CITY OF NEWPORT BEACH PLANNING COMMISSION STAFF REPORT

December 7, 2017
Agenda Item No. 5

SUBJECT: Ginsberg Residence (PA2016-170)

SITE LOCATION: 2607 Ocean Boulevard

ROOF PLAN

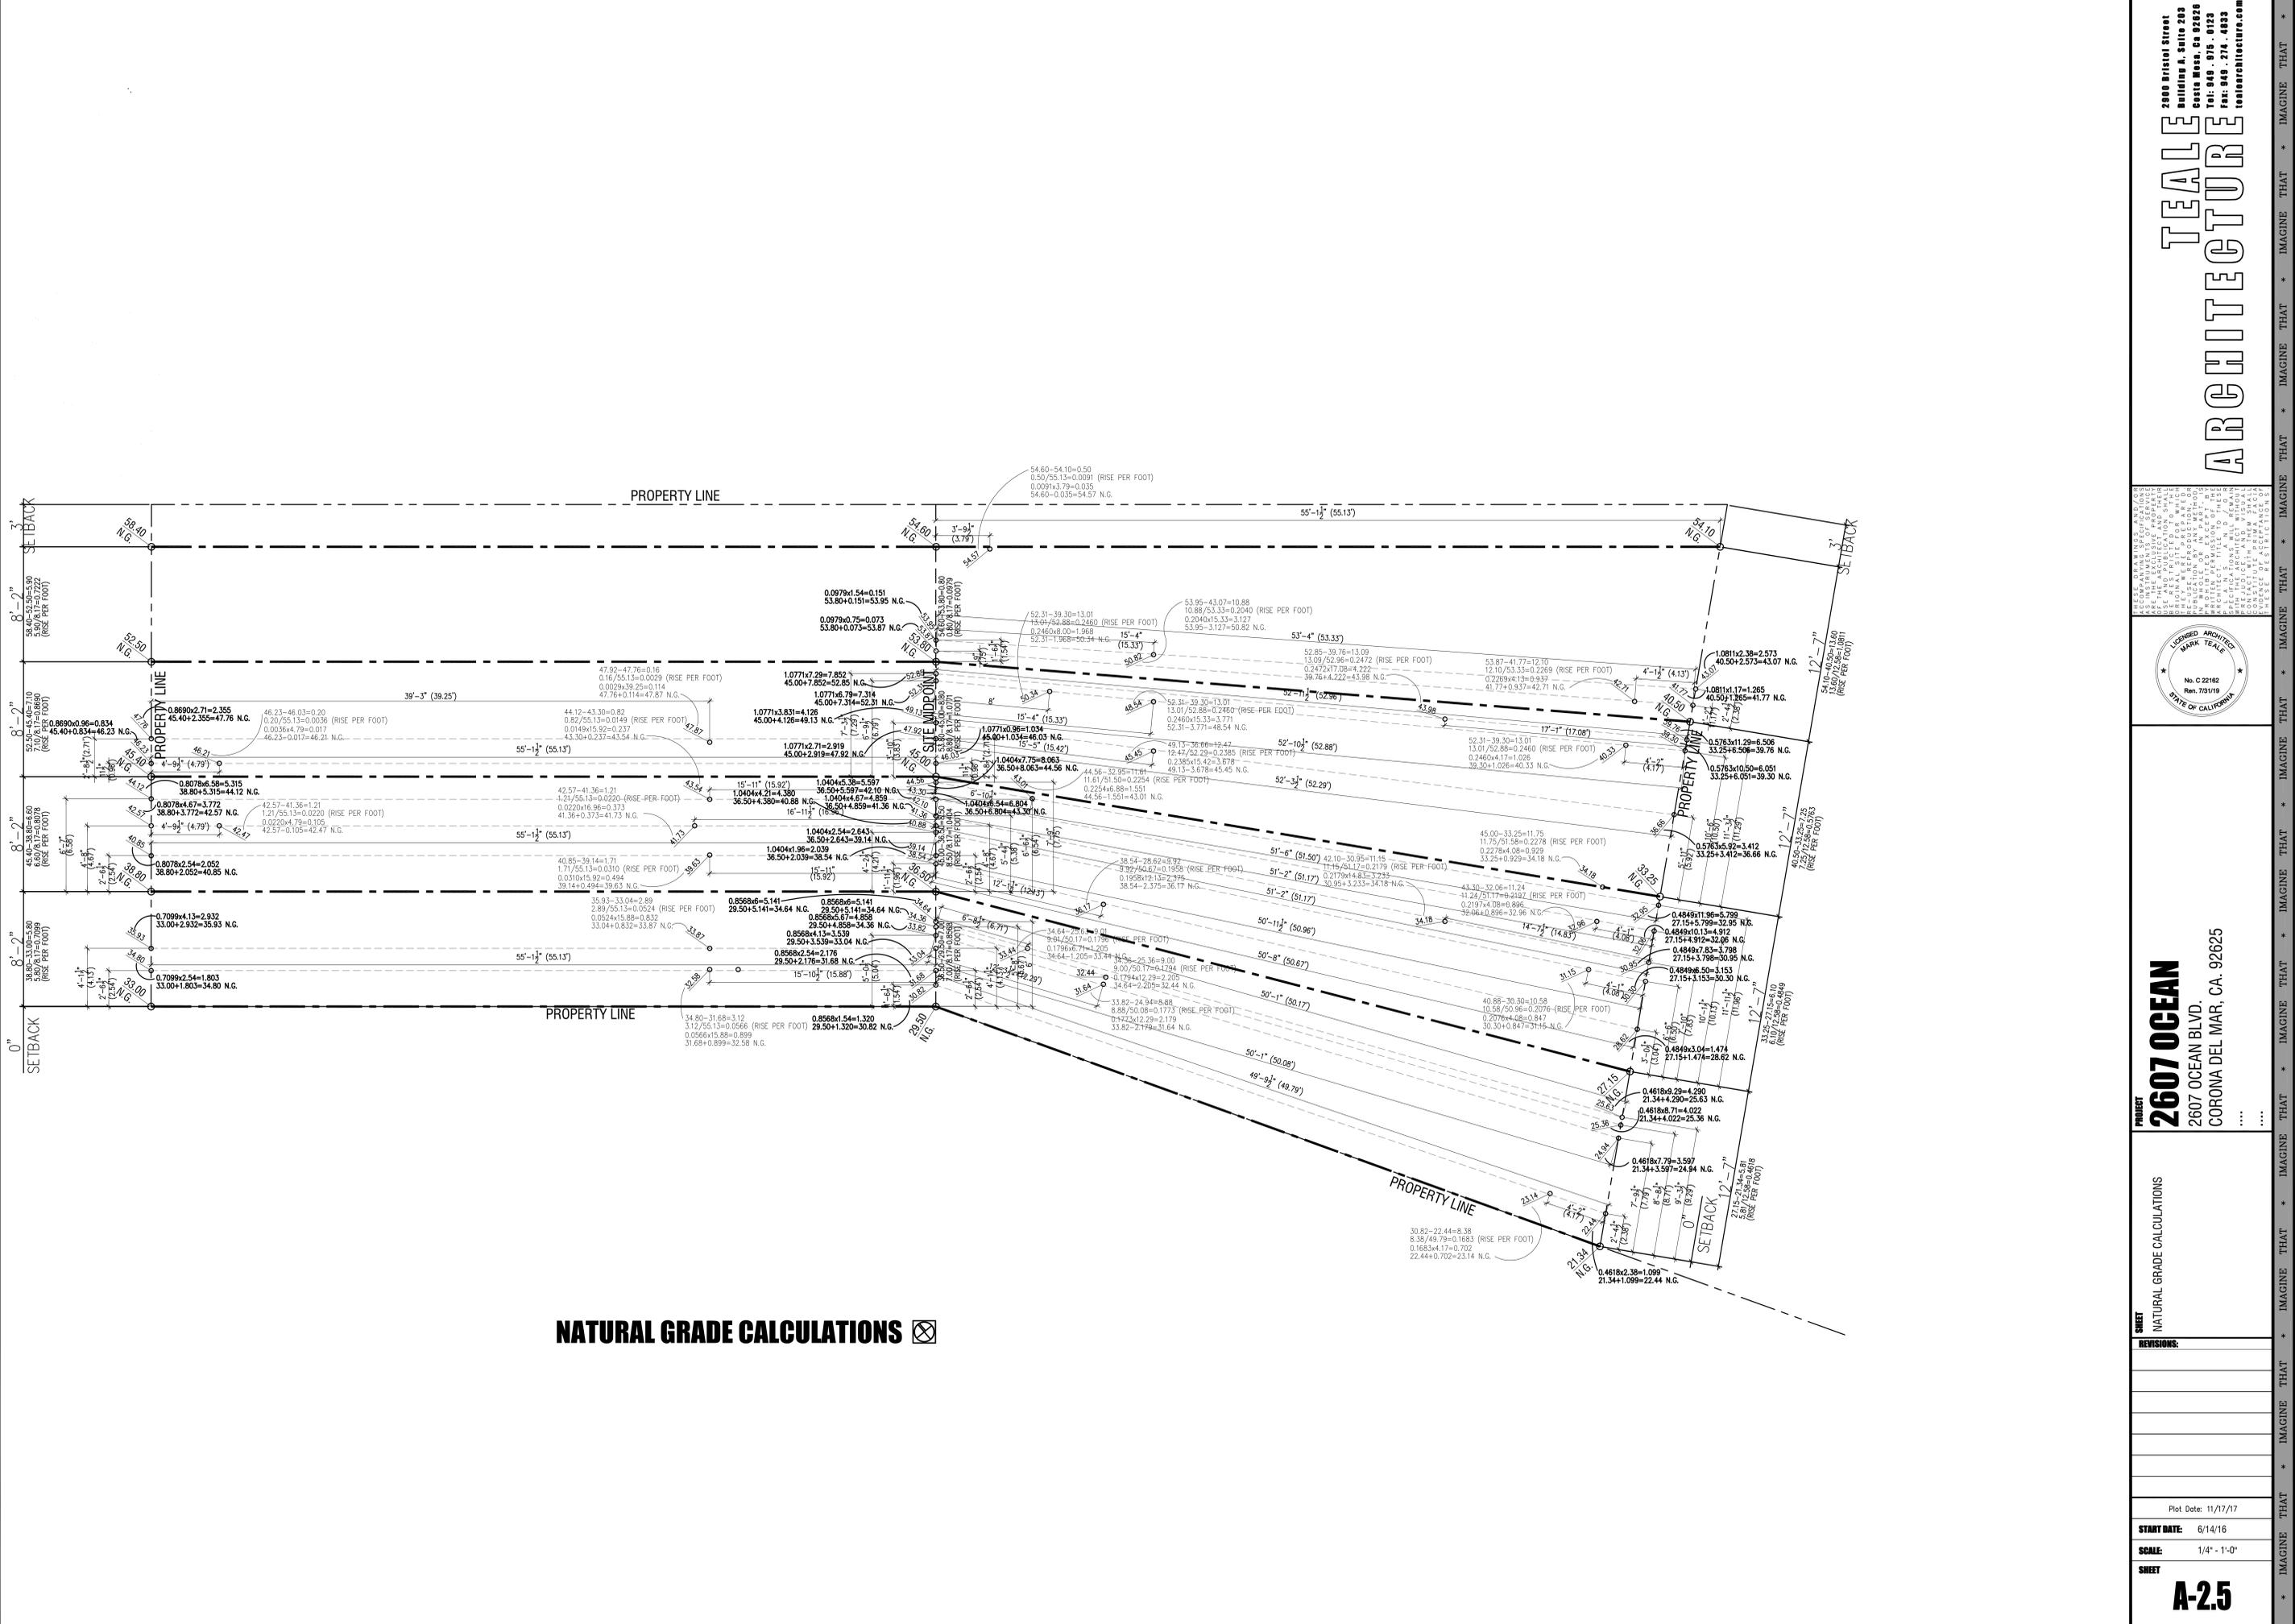
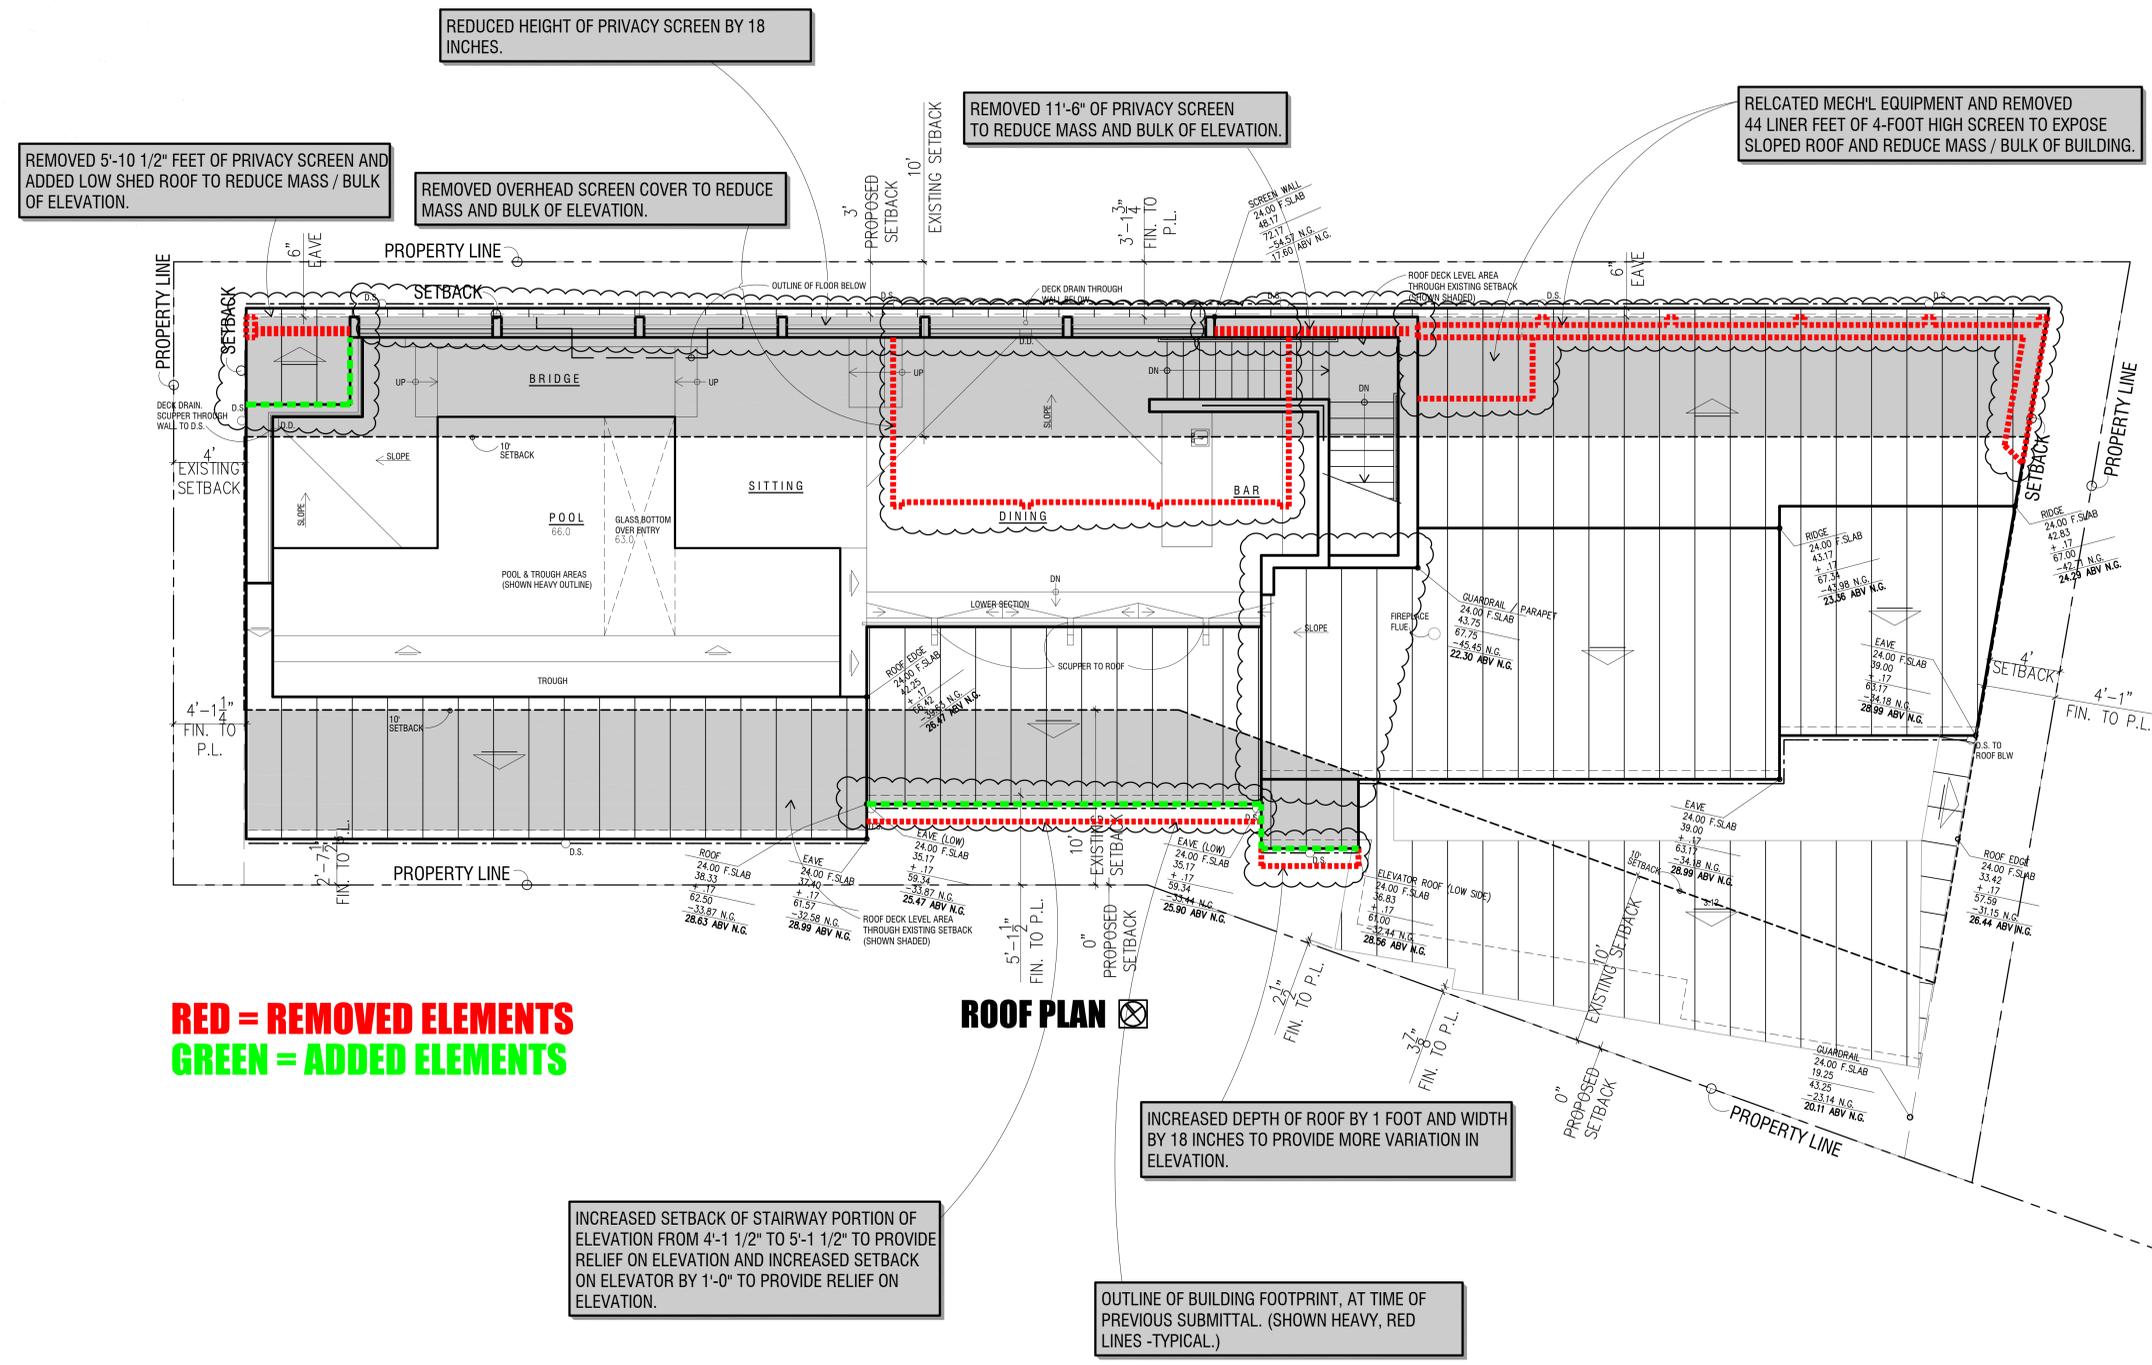
REMOVED 11'-6" OF PRIVACY SCREEN TO REDUCE MASS AND BULK OF ELEVATION.

RELICATED MECH'L EQUIPMENT AND REMOVED 44 LINER FEET OF 4-FOOT HIGH SCREEN TO EXPOSE SLOPED ROOF AND REDUCE MASS / BULK OF BUILDING.

INCREASED SETBACK OF STAIRWAY PORTION OF ELEVATION FROM 4'-1 1/2" TO 5'-1 1/2" TO PROVIDE RELIEF ON ELEVATION AND INCREASED SETBACK ON ELEVATOR BY 1'-0" TO PROVIDE RELIEF ON ELEVATION.

INCREASED DEPTH OF ROOF BY 1 FOOT AND WIDTH BY 18 INCHES TO PROVIDE MORE VARIATION IN ELEVATION.

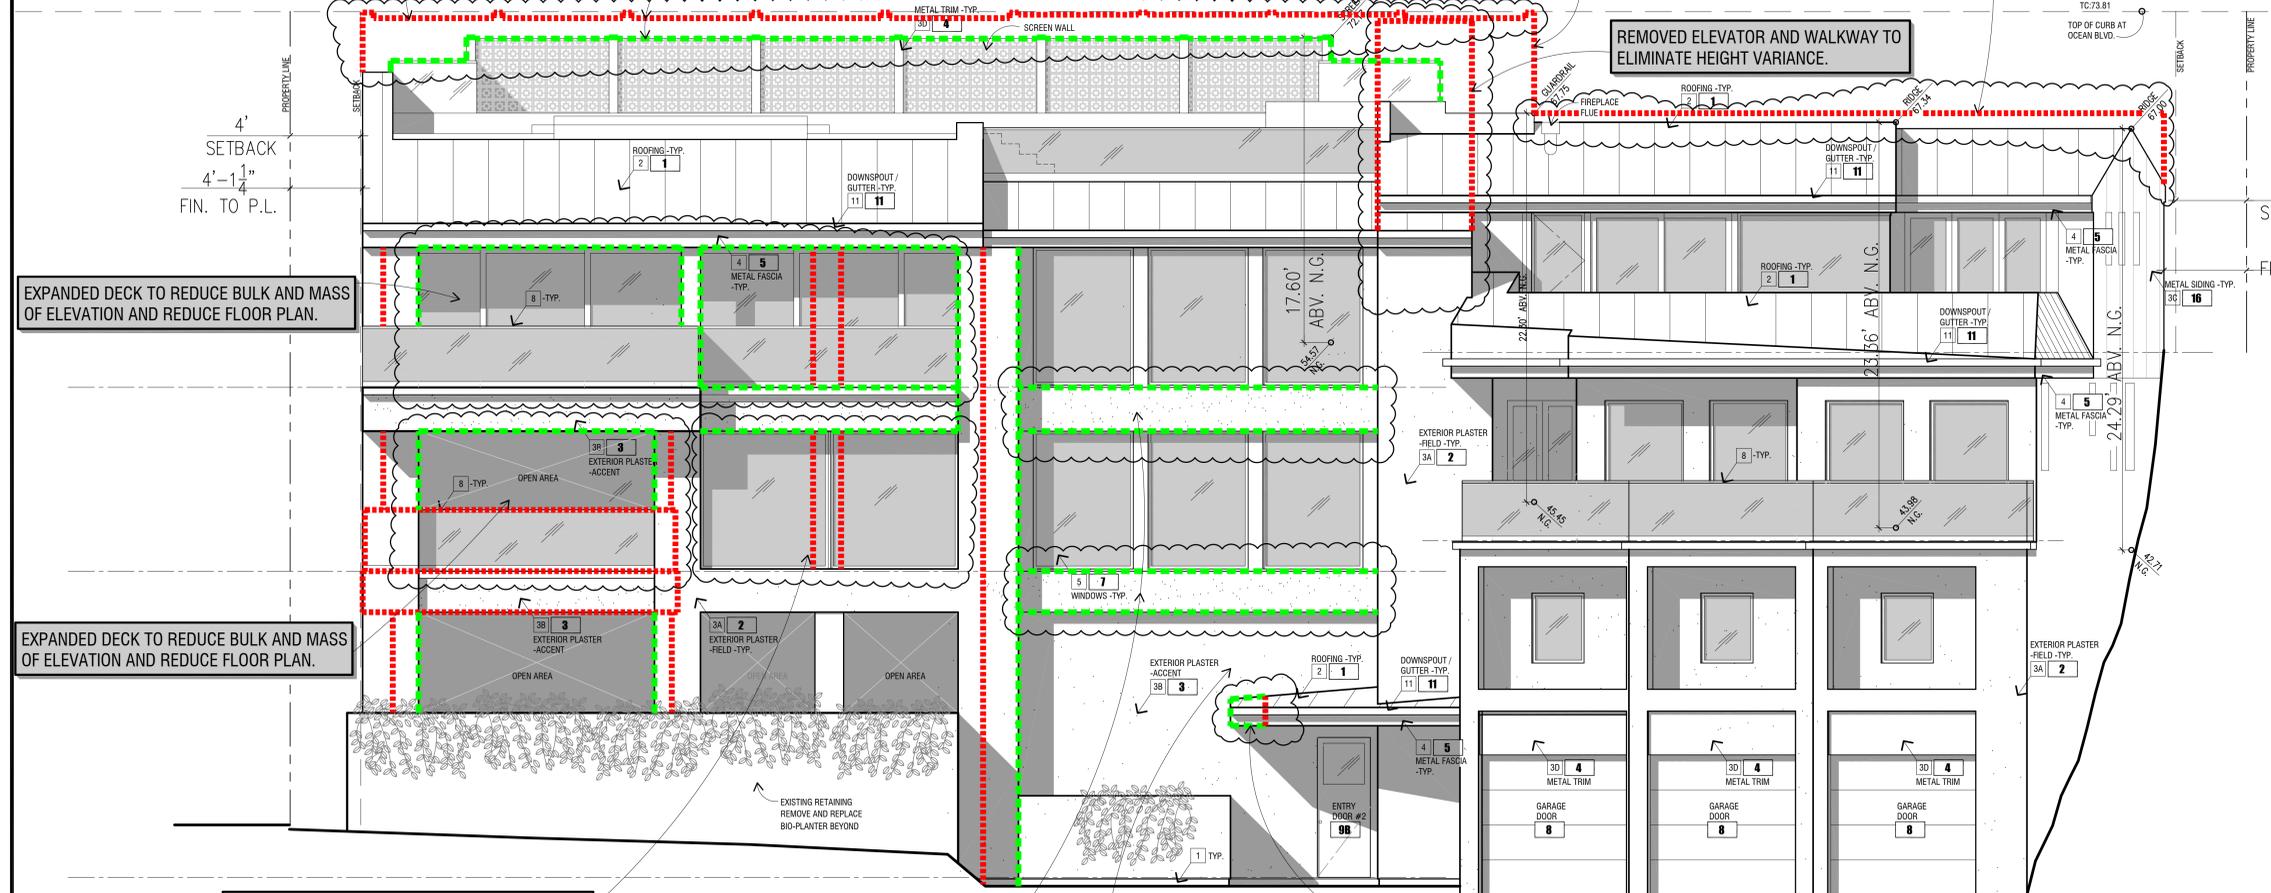
REMOVED 5'-10 1/2" FEET OF PRIVACY SCREEN AND ADDED LOW SHED ROOF TO REDUCE MASS / BULK OF ELEVATION.

REDUCED HEIGHT OF PRIVACY SCREEN BY 18 INCHES.

SECTION C-C

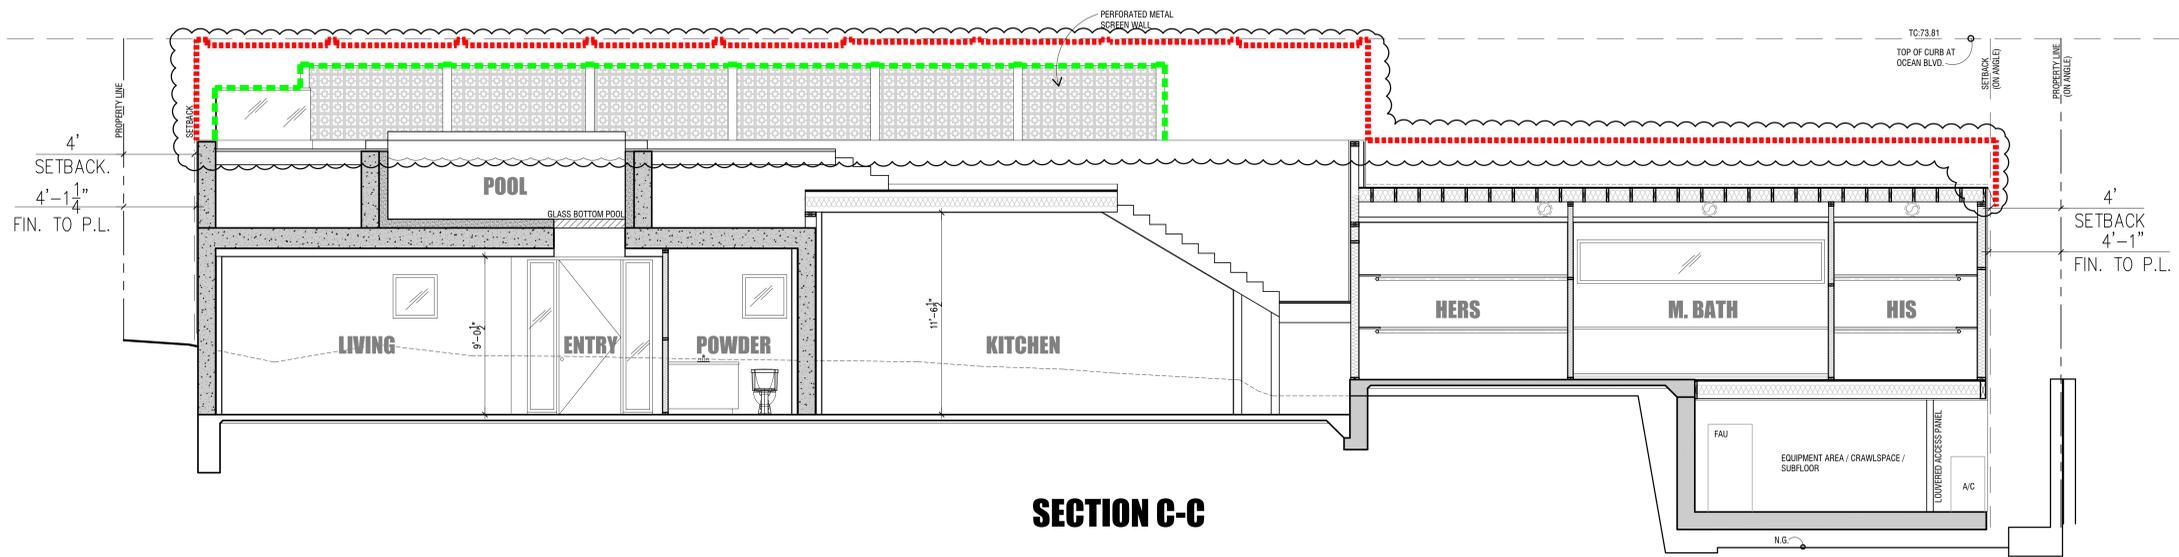
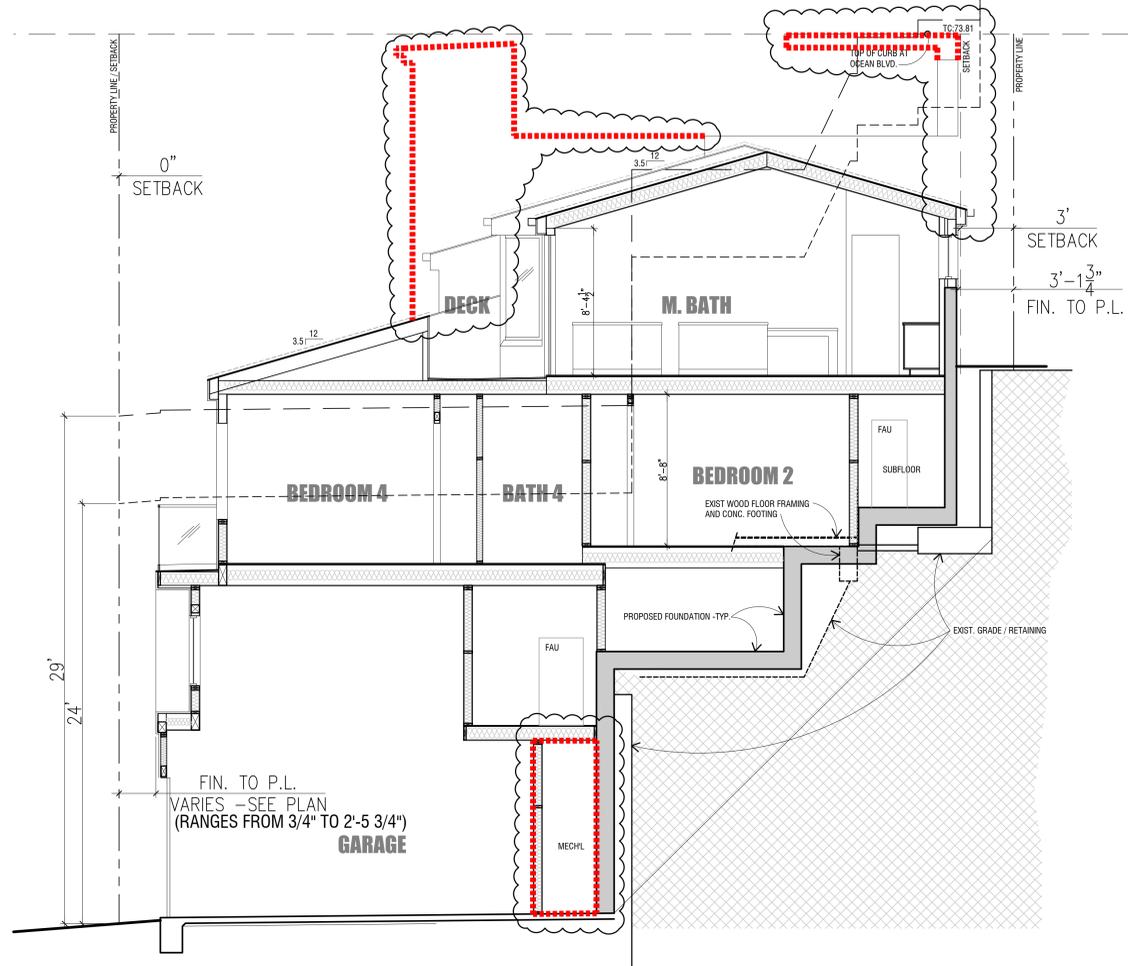
UPDATED CROSS-SECTIONS TO REFLECT CHANGES TO THE HEIGHT AND EXTERIOR ELEVATIONS OF PROPOSED HOME.
